BID ADDENDUM 1

Project: Warwick Valley CSD
High School
Unit Ventilator Replacement & Air Conditioning Upgrade

Engineer: Eisenbach & Ruhnke Engineering, P.C.
291 Genesee Street
Utica, NY 13501
E&R Project #: 05-21-04

PROJECT NO.	05-21-04 05-20-06
BID ADDENDUM ISSUED FOR BID	11.23.2022 11.09.2022
SED SET	10.19.2022
REVISION	DATE
DRAWN BY	
CHECKED BY	
SHEET SIZE	30" X 42"
SCALE	AS NOTED
SHEET TITLE	STRUCTURAL PLANS AND MISCELLANEOUS DETAILS
SHEET NO.	HS A-101

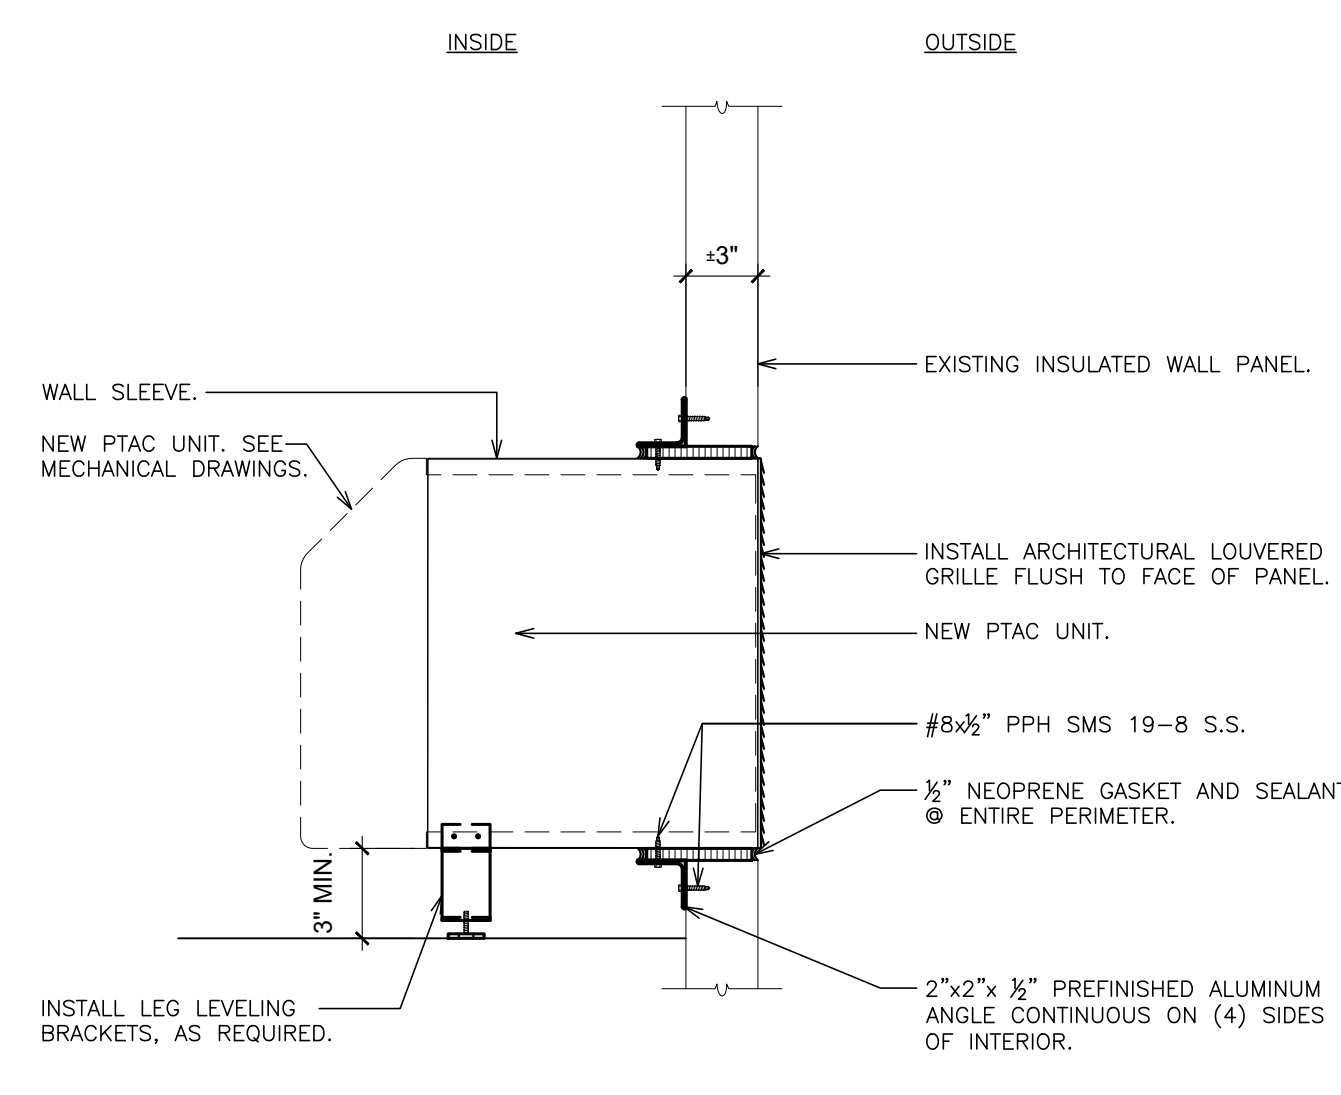
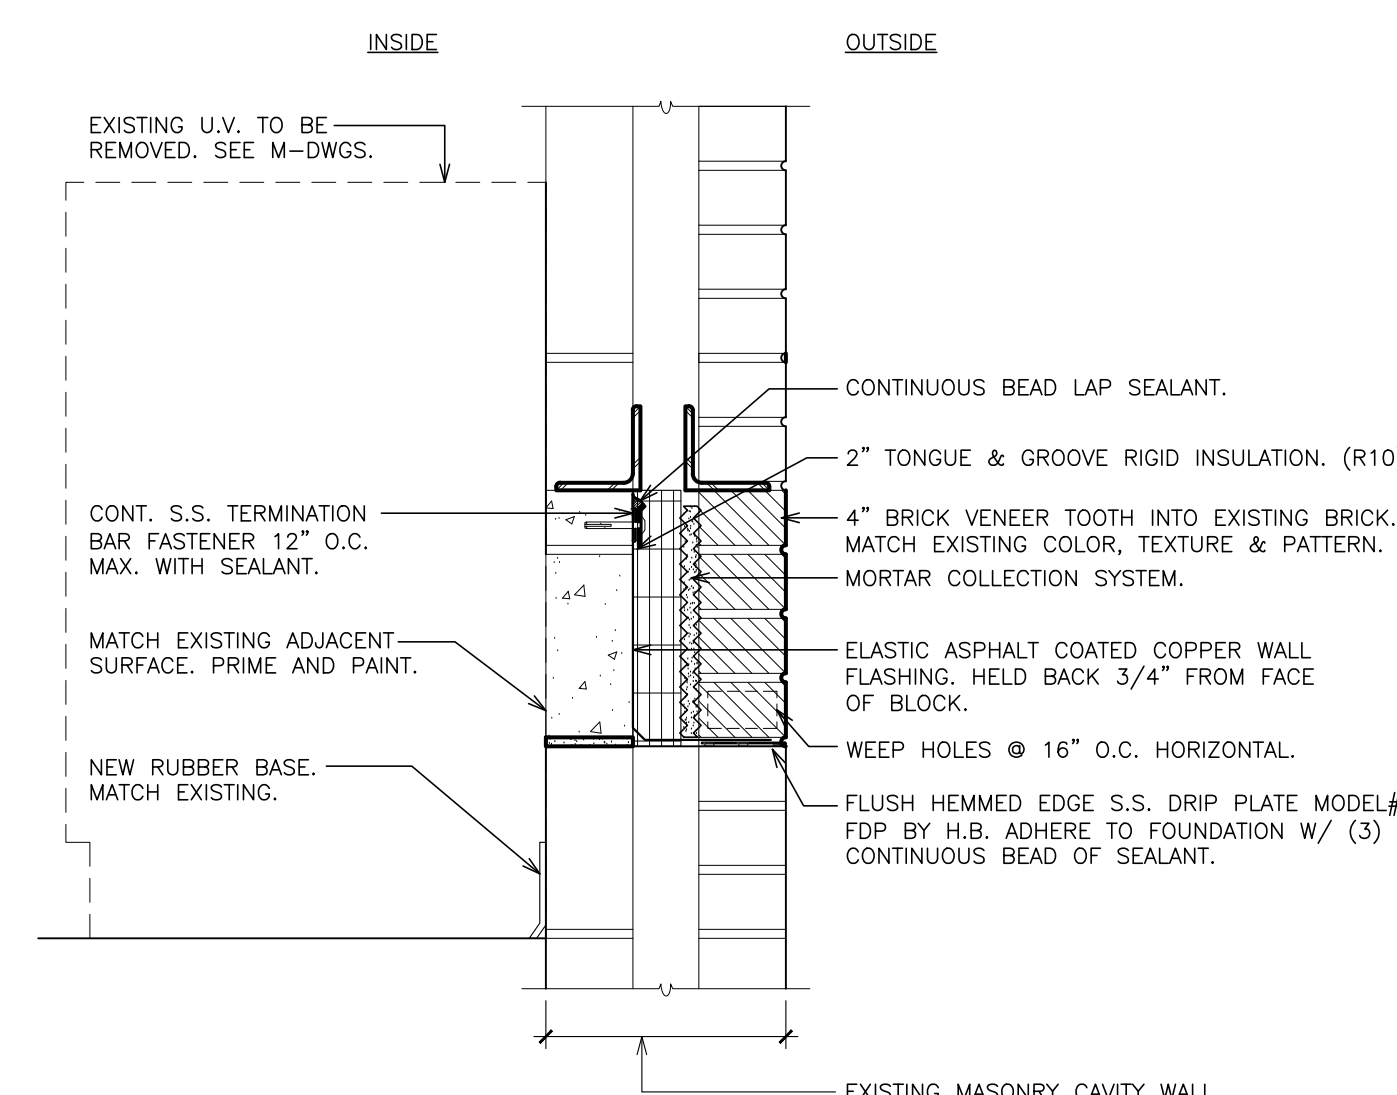
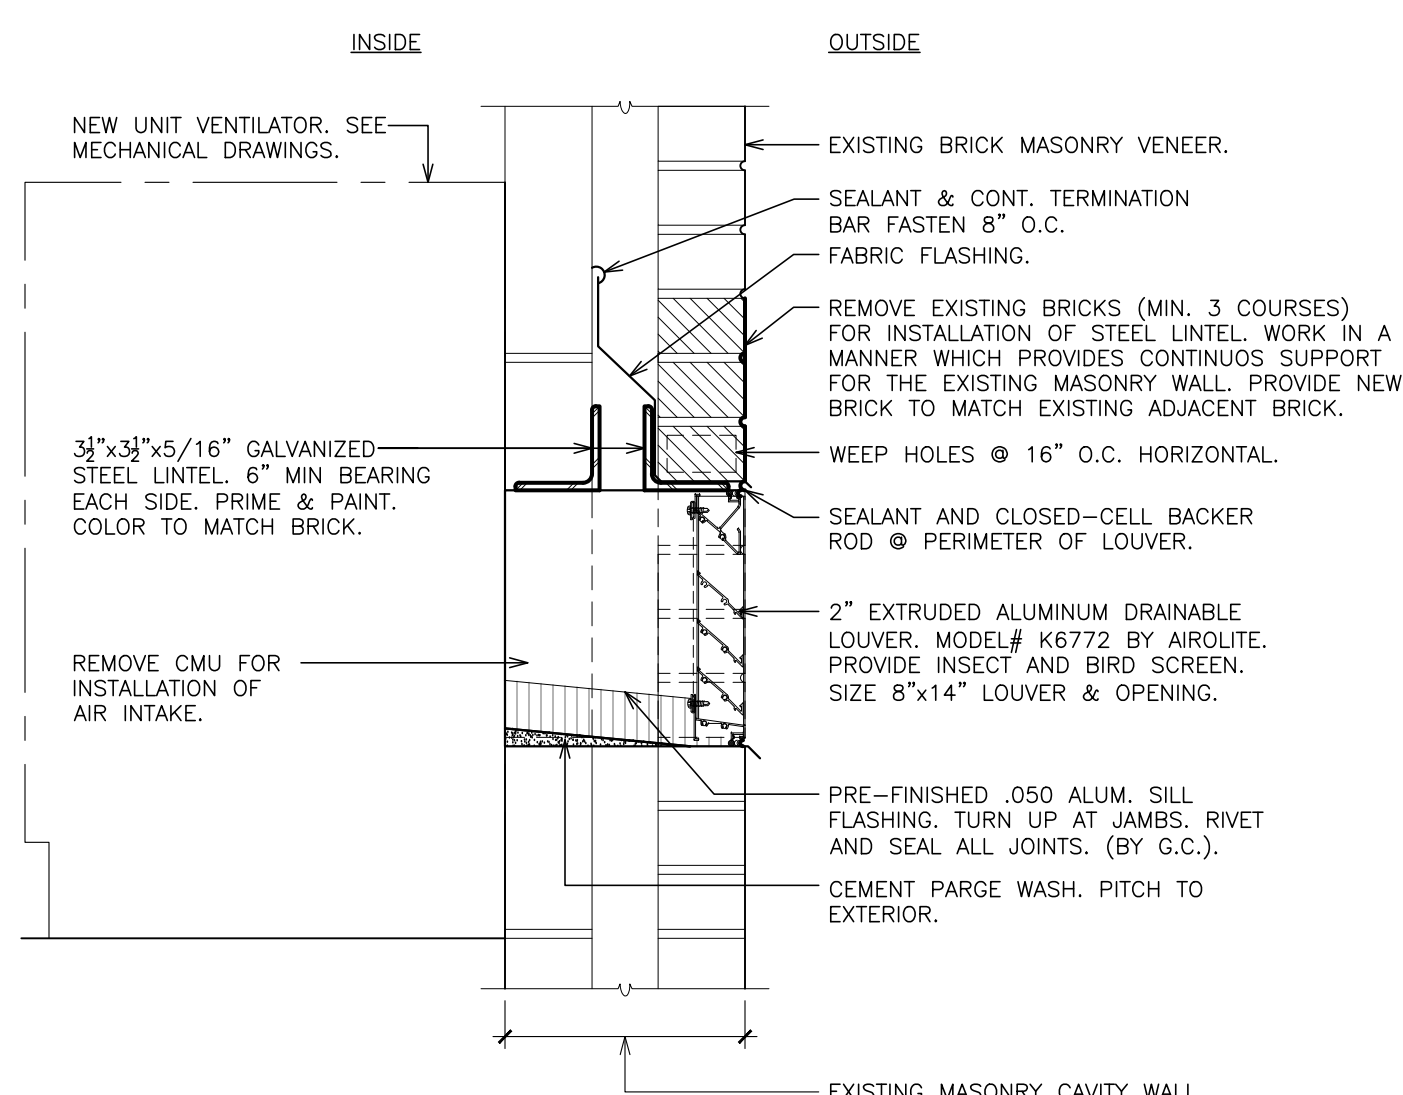
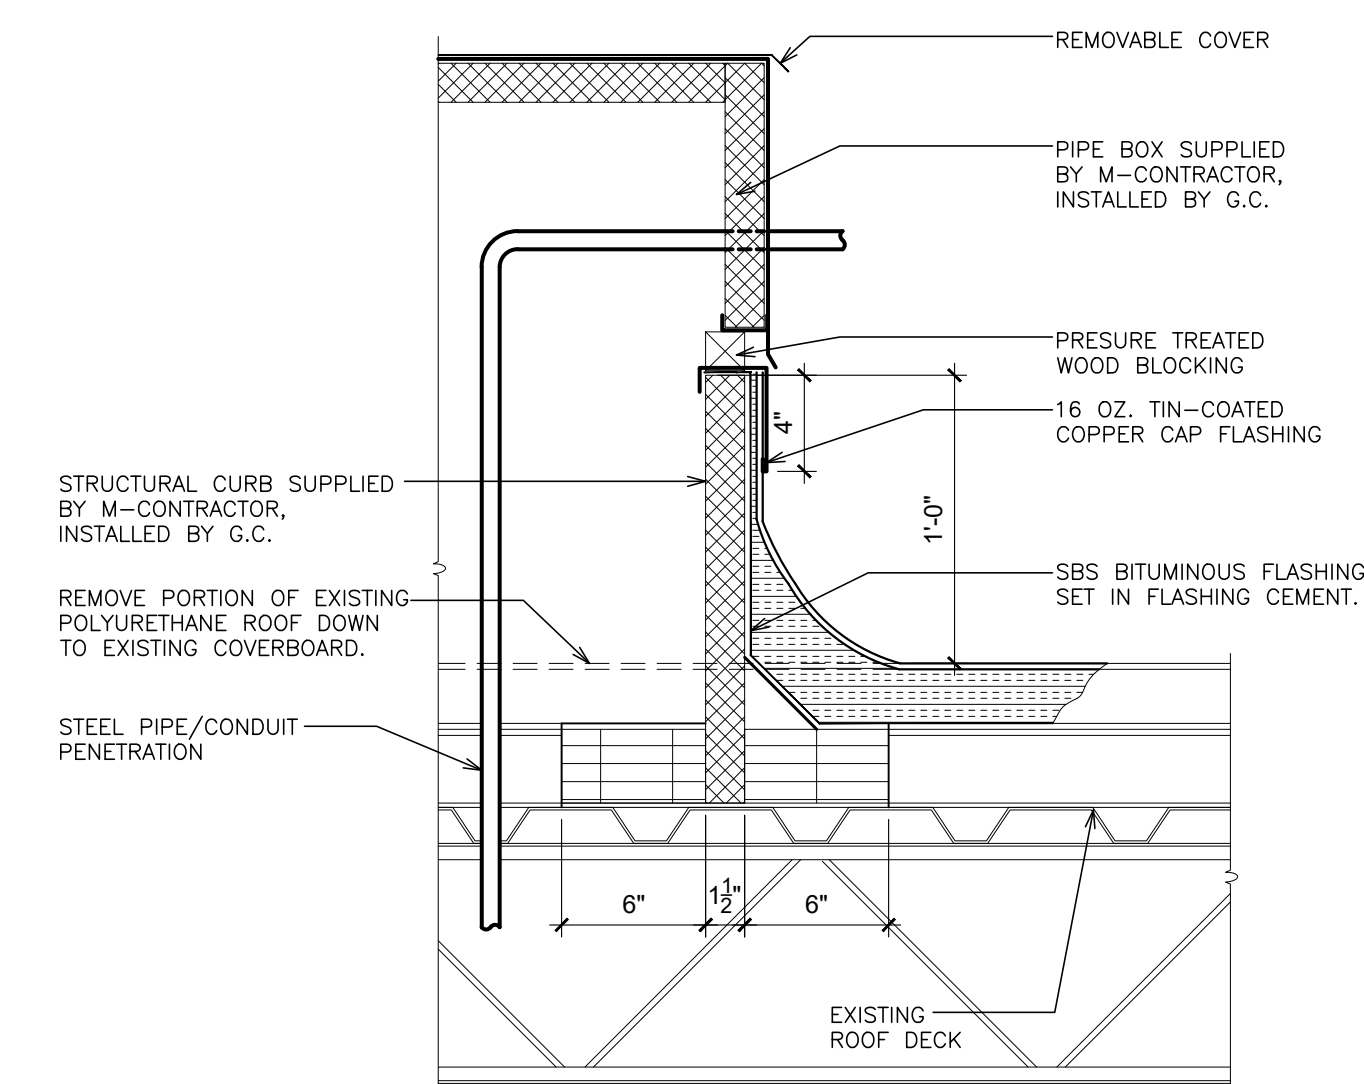
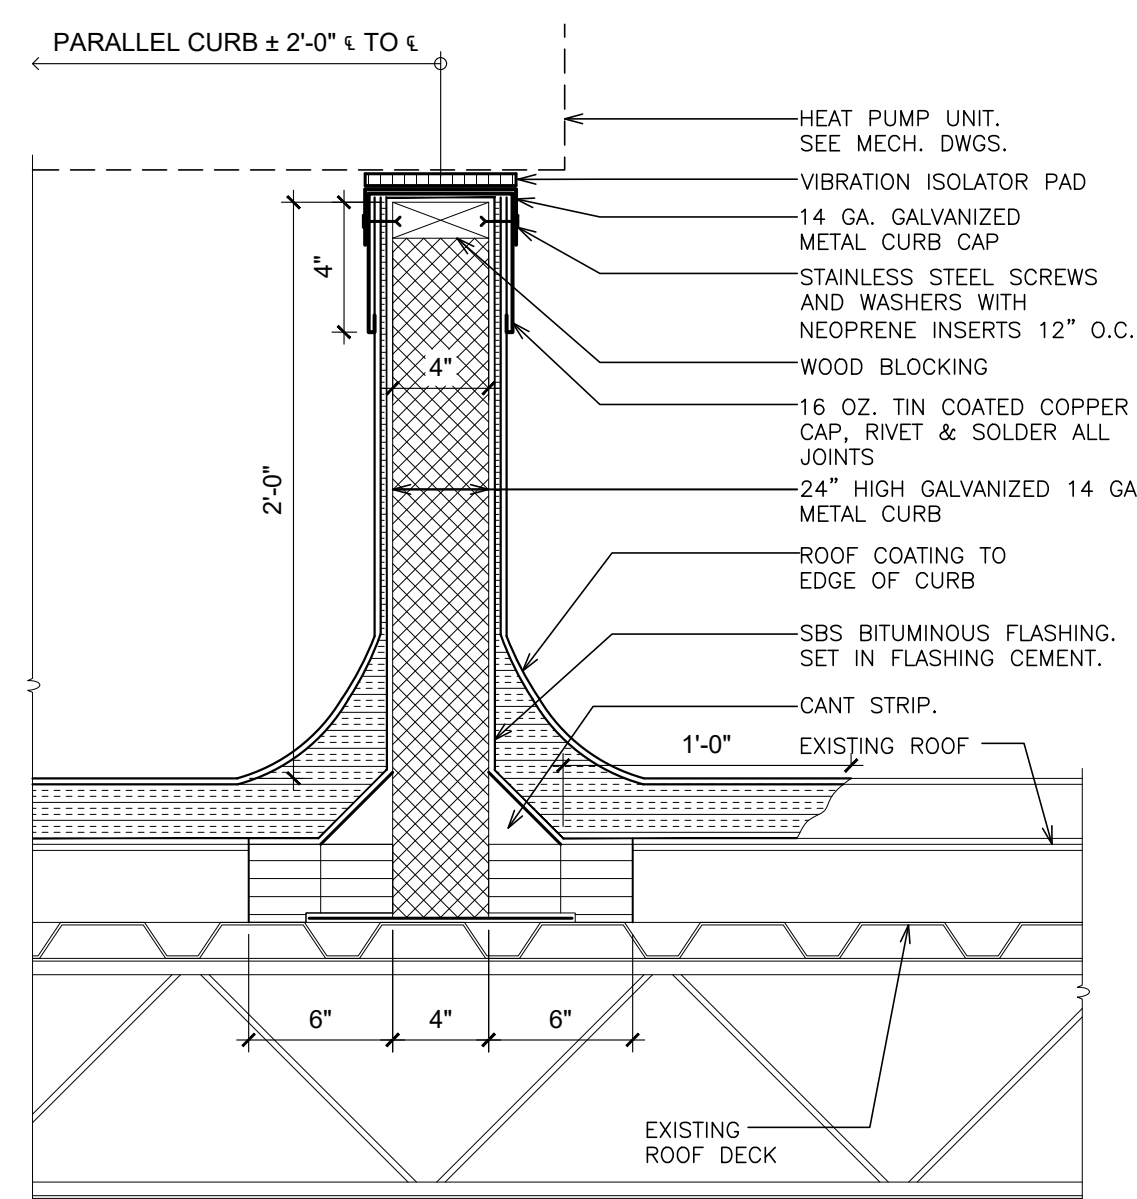
1. Is the masonry on drawing A101 by the MC or the Roofer? Please advise **MASONRY WORK IS BY MC.**
2. Is the flashing on drawing A101 by the Roofer or MC? **ROOF CURB FLASHING IS BY ROOFER.**

3. On detail 6 on drawing A101 the word GC is mentioned. Is this the roofer or the MC as there is no GC bid? Please advise. **IN THIS CASE - GC SHALL MEAN ROOFER.**
